**PZHAC WORK SESSION
AGENDA
JUNE 18, 2018**

**PZHAC REGULAR MEETING
AGENDA
JUNE 18, 2018**

**PZHAC WORK SESSION
JUNE 18, 2018
ITEM 1**

**PZHAC WORK SESSION
JUNE 18, 2018
ITEM 2**

VIEW OF EAST SIDE OF PROPERTY

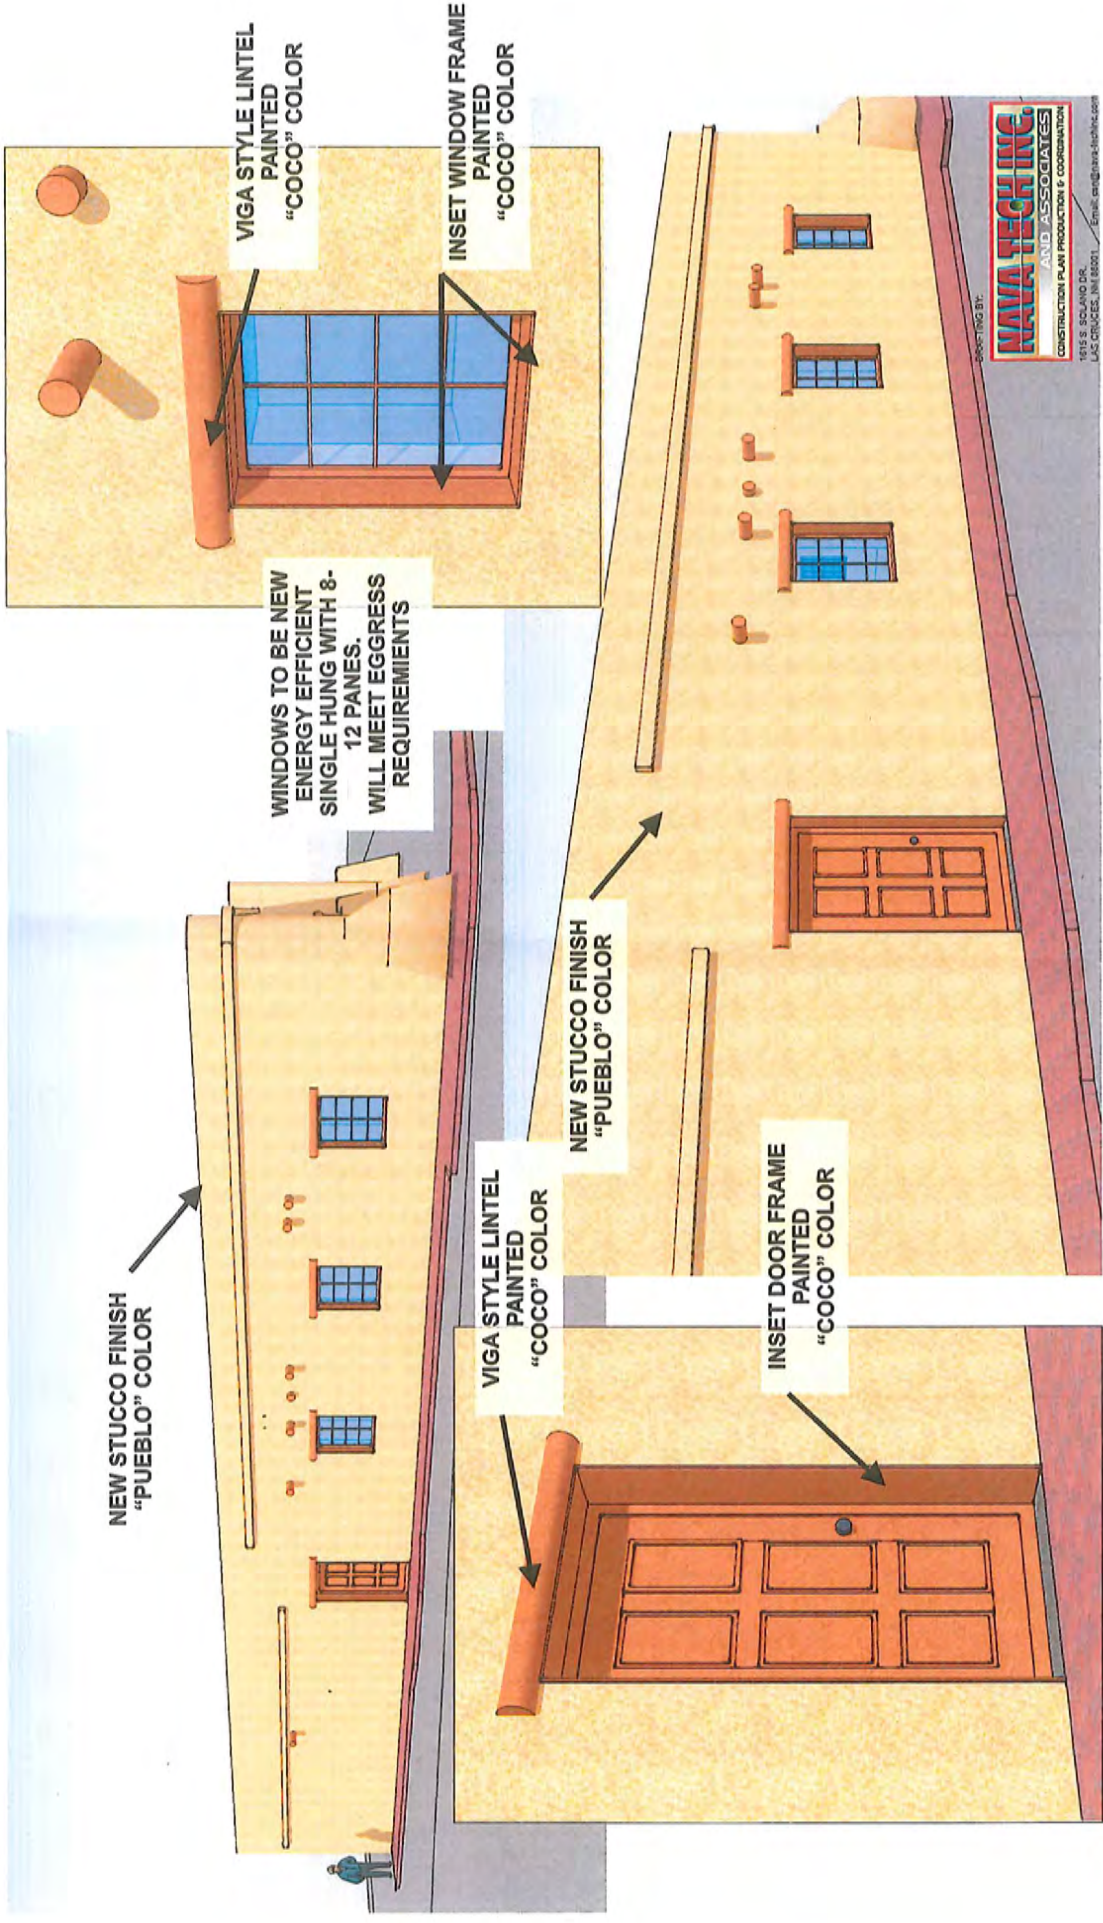
The applicant would like to replace or repair the existing windows in order to improve the thermal efficiency of the windows, as well as to repair existing frames that have become worn and deteriorated due to use and weather. The applicant would also like to replace or repair the ends of existing vigas on the front exterior wall of the structure and add vigas to places where they appear to be missing. The applicant will then repair and repaint any stucco that has been damaged. This will be painted to match the remainder of the existing stucco.
